L-2012-018
10 CFR 52.3

Re: Florida Power & Light Company
Proposed Turkey Point Units 6 and 7
Docket Nos. 52-040 and 52-041
Response to NRC Request for Additional Information Letter No. 043
(eRAI 5875) SRP Section - 02.05.03 Surface Faulting

NRC RAI Letter No. PTN-RAI-LTR-043

SRP Section: 02.05.03 – Surface Faulting

Figure 1. Illustration from USACE lineament study and Barnett (1975) strike-slip fault

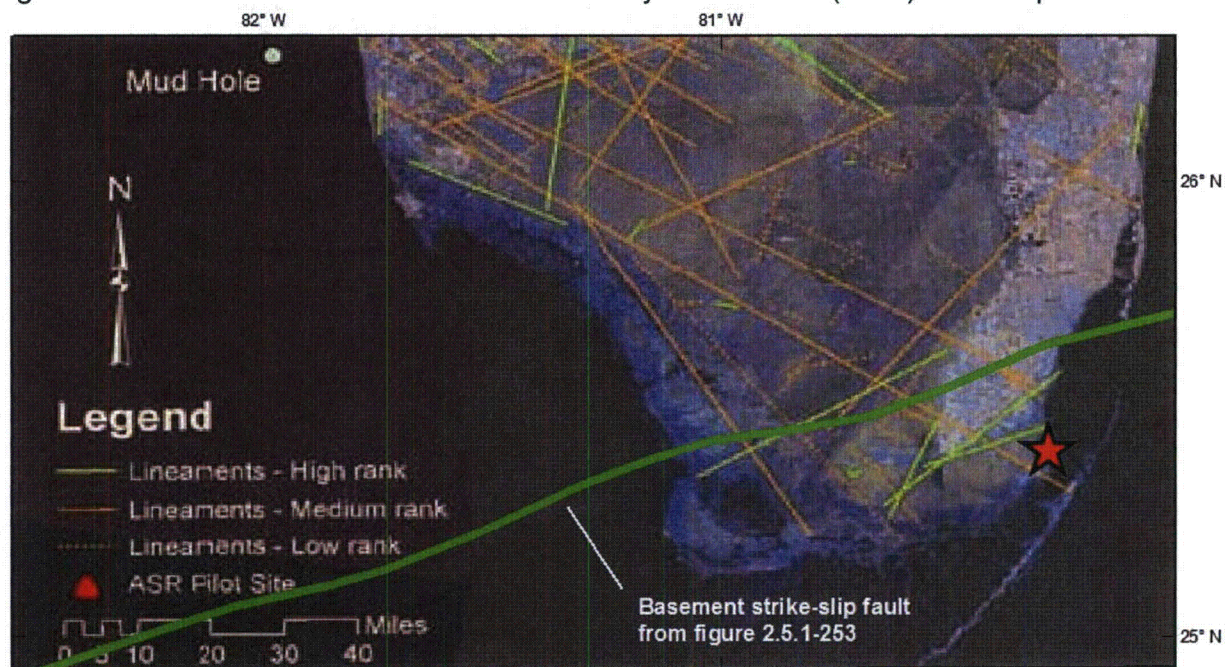
FSAR Section 2.5.3.2, "Geological Evidence, or Absence of Evidence, for Surface Deformation", states that published geologic mapping at a range of scales show no bedrock faults mapped within the site vicinity (References 211, 213, 224, and 226). However, the staff note, that Figure 2.5.1-253 depicts a strike-slip fault within 25 miles of the site; this feature is also shown as a high-rank lineament on Figure 2.5.3-204.

In order for the staff to completely understand the geologic setting of the site and in support of 10 CFR 100.23 please discuss the high-rank lineament shown on Figure 2.5.3-204, and clarify it's relationship with the strike-slip fault north of TPNPP shown on Figure 2.5.1-253. Include a discussion regarding how these figures are in agreement with the FSAR Section 2.5.3.2 statement that no faults have been mapped in the site vicinity. Finally, please clarify this apparent disagreement between the text and figures in the appropriate FSAR section(s).

As described in FSAR Subsection 2.5.3.1.2, the USACE mapped a variety of lineaments in southern Florida (FSAR 2.5.3 Reference 232). This study used Landsat imagery at scales between 1:1,000,000 and 1:125,000. The lineaments were not field checked, and the authors indicate that "a considerable number of the mapped lineaments may be dismissed after further investigation" (FSAR 2.5.3 Reference 232, p. 50). The northeast-trending 'high-rank' lineament in question was not identified in previous lineament analyses that included southern Florida (FSAR 2.5.3 Reference 232). The lack of supporting corroborating analyses on the existence of the lineament, the coarse nature of the lineament identification study dictated by the small scales at which the lineament analysis was conducted, and the lack of field evidence all provide poor evidence for the existence and geometry of the high-rank lineament.

As described in FSAR Subsection 2.5.1.1.1.13.2.1, the postulated basement faults shown on Figure 2.5.1-253 are drawn to accommodate potential misfits in plate tectonic reconstruction models or differences in lithology from widely separated boreholes, and thus, little evidence directly indicates actual displacement has occurred on these postulated structures. There is no clear relationship between the postulated buried strike-slip basement fault depicted in Figure 2.5.1-253 and the high-rank lineament on Figure 2.5.3-204. As shown in Figure 1, the two features are both northeast-striking, but have different geometries, extents, and locations. No geologic evidence of faulting is reported to support a tectonic origin for the lineaments identified in the study, and no evidence was provided to relate the postulated basement faults at depth to any lineament at the surface (FSAR 2.5.3 Reference 232). The original study did not interpret a geomorphic expression for any of the postulated basement faults depicted in Figure 2.5.1-253 (FSAR 2.5.1 Reference 458).

FPL interprets the similarity in general location (southern Florida) and strike (northeast) to be coincidental.

There is no evidence for faulting along any of the lineaments within the site vicinity in FSAR Figure 2.5.3-204, therefore, this feature does not conflict with any statement made in the FSAR. The FSAR will be revised, however, to reflect the existence of a postulated buried basement fault shown in Figure 2.5.1-253 within the site vicinity.

Figure 1. Map of McGregor Isles area

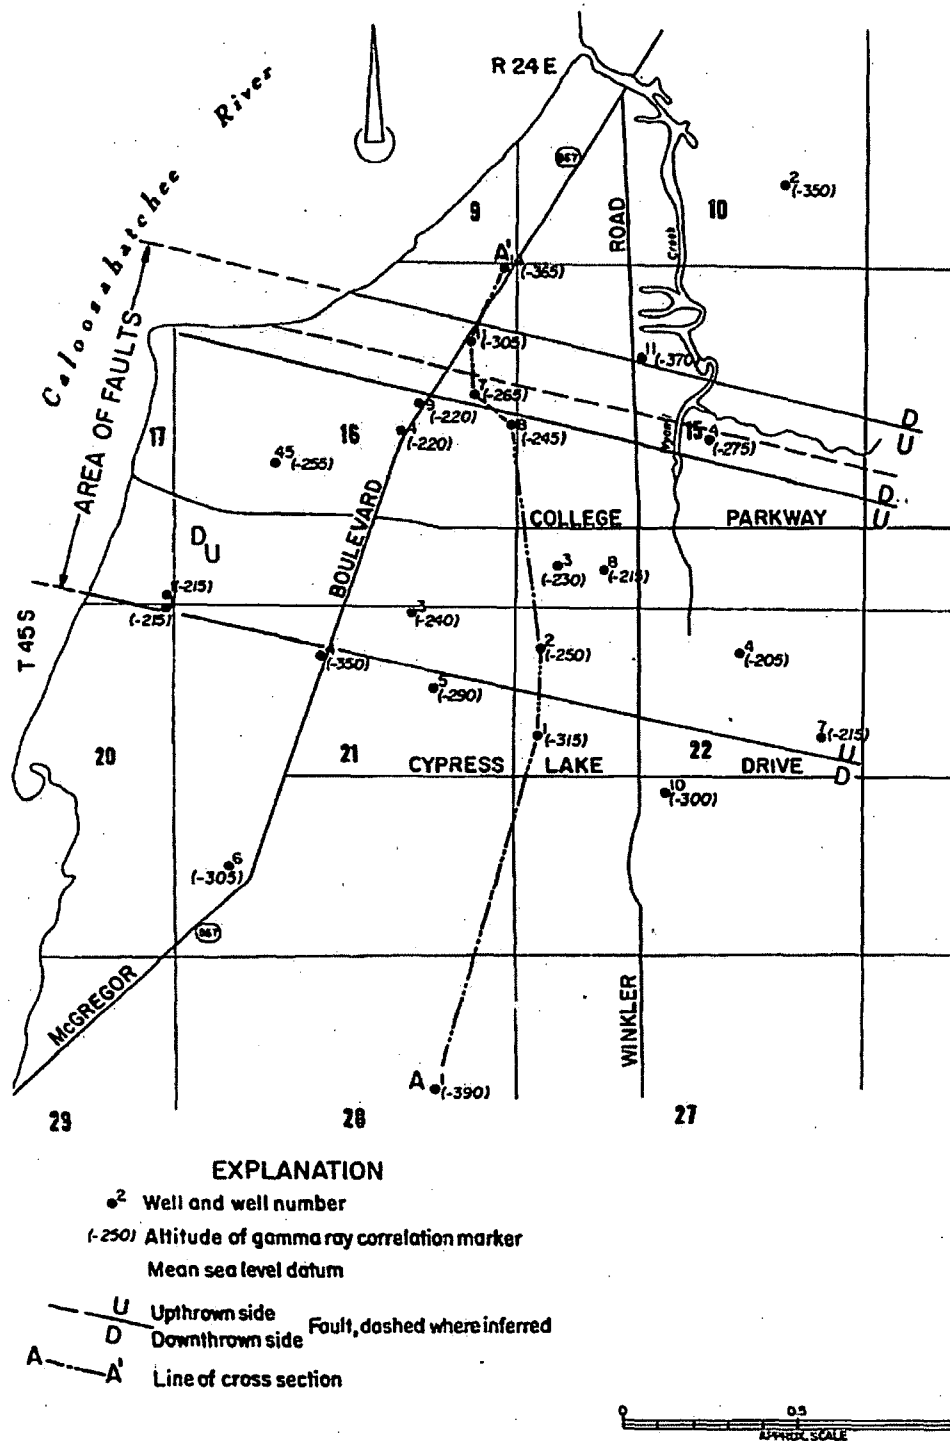
In order for the staff to understand evidence for or against tectonic deformation in Florida Platform specific geology and in support of 10 CFR 100.23, please clarify the apparent inconsistent conclusions that Sproul et al (Reference 230) drew regarding these possible faults. Describe the geomorphic features that Sproul et al referred to and provide more details of your field reconnaissance examination of this area completed for this application.

Sproul et al. suggest that the 'configuration of the Caloosahatchee River shoreline in the vicinity of the northeast corner of section 17 (in Figure 1), and the alignment of a tributary to Whisky Creek near the center of section 15 are suggestive of fault controlled features

(p. 12 of FSAR 2.5.3 Reference 230) (Figure 1). However, the shoreline throughout the northwest corner of section 16, and the southwest corner of section 17 does not indicate an alignment with the faults (Figure 1) and the orientation of the main creek drainage in section 15 is at high angles to the trace of the mapped faults, with no apparent offset or deflection along the proposed structures (Figure 1).

Figure 2. Interpreted borehole section from Sproul et al.

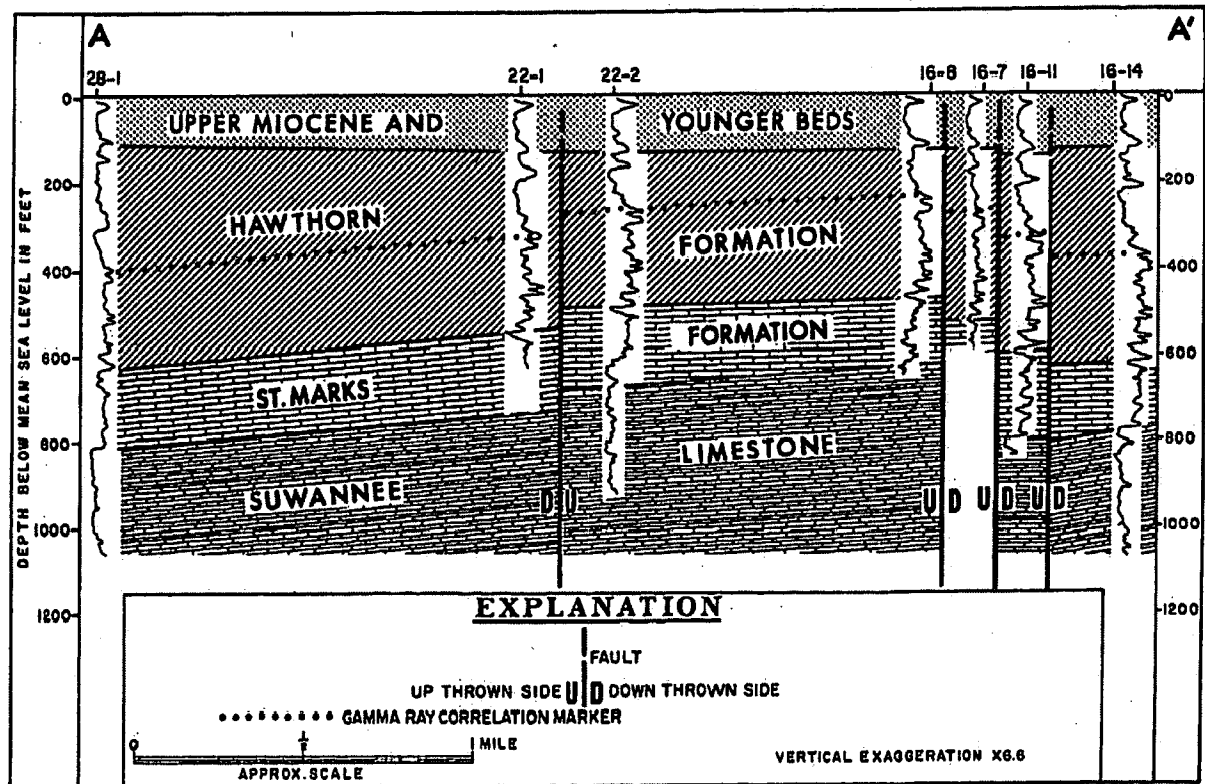
FSAR Section 2.5.3.2, states in the "Geological Evidence, or Absence of Evidence, for Surface Deformation passage", that "the second feature beyond the site vicinity investigated as part of geologic field reconnaissance includes possible faults identified from borehole data in the McGregor Isles area near Ft. Myers, 120 miles northwest of the site. Based on gamma-ray logs from several wells, Sproul et al. (Reference 230) interpret faulting of pre-upper Hawthorn (Miocene) strata. In spite of their interpretation that overlying upper Hawthorn and younger strata are unfaulted, Sproul et al. (Reference 230) suggest possible geomorphic indicators of faulting." The staff notes that possible geomorphic indicators of faulting appear to be inconsistent with the finding that upper Hawthorn and younger strata are unfaulted at the McGregor Isles are.

The faults discussed in FSAR Subsection 2.5.3.2 were interpreted on the basis of variation in elevation of a distinctive peak in the gamma-ray logs which was taken as a correlation horizon in several boreholes at depth beneath portions of Ft. Myers, Florida. The correlation horizon is found within the Miocene Hawthorne strata and shows elevations which vary from -390 to -205 feet NAVD 88. The apparent vertical offsets range from 50 to 110 feet across the interpreted faults (FSAR 2.5.3 Reference 230). Faulting occurred after deposition of the correlation horizon and before the deposition of the upper part of the Hawthorn Formation. The upper horizons of the Hawthorn Formation did not have obvious displacements (FSAR 2.5.3 Reference 230) (Figures 1 and 2). These data provide the only direct information regarding the timing of potential fault movements. The 'possible geomorphic indicators of faulting' were not specifically correlated with post-Miocene fault activity (FSAR 2.5.3 Reference 230). If the geomorphic features noted by Sproul et al. were clearly tied to fault activity, it would indeed be inconsistent with the timing of faulting indicated by the borehole data. Given the apparent inconsistency between interpreted geomorphology and borehole data, FPL interprets only the borehole data to have actual bearing on the ages of these faults.
